SA555DR

Question

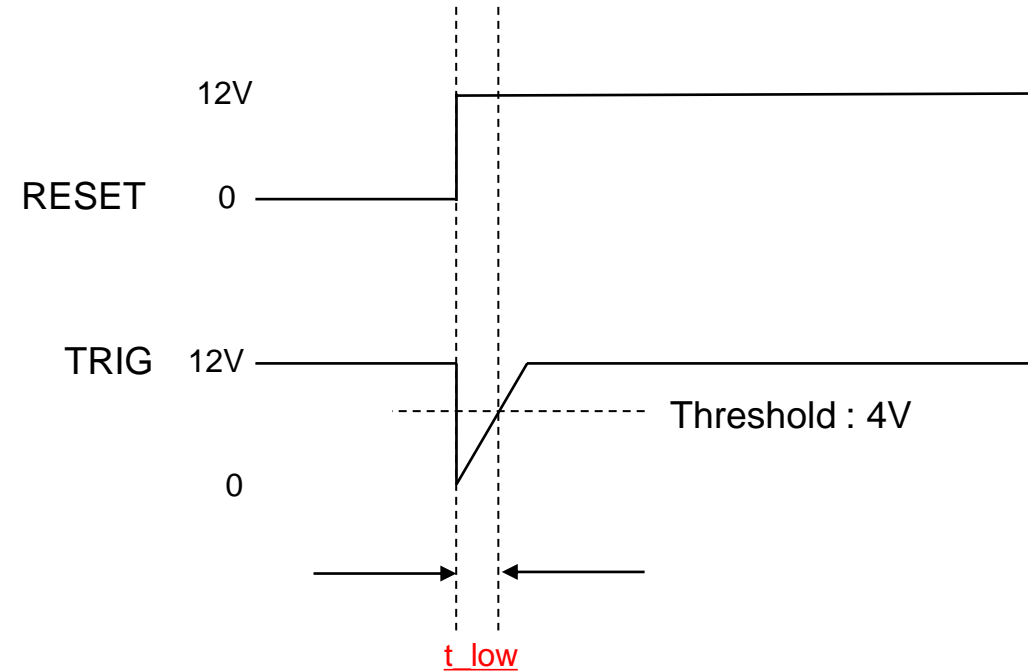
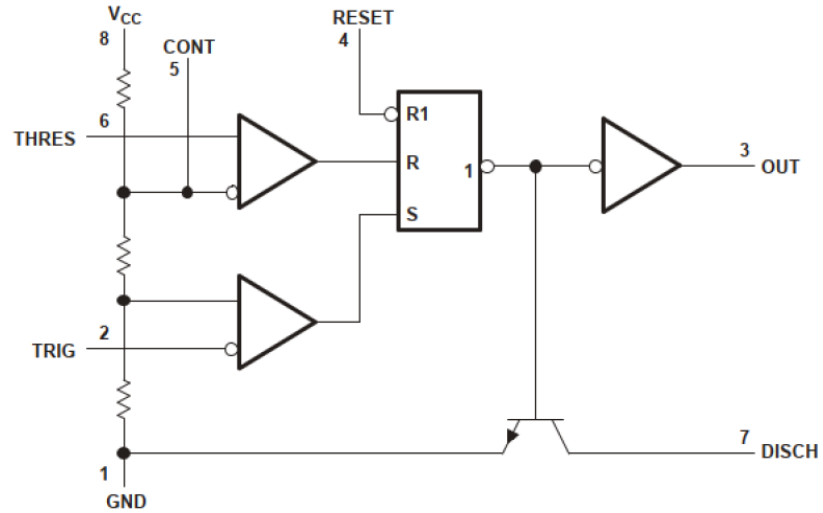
In case the timing of “release RESET” and “Trigger signal (Low)” is the same, how long should we hold the trigger low time (t_{low})?

Will you tell me the min value? (**uSec)
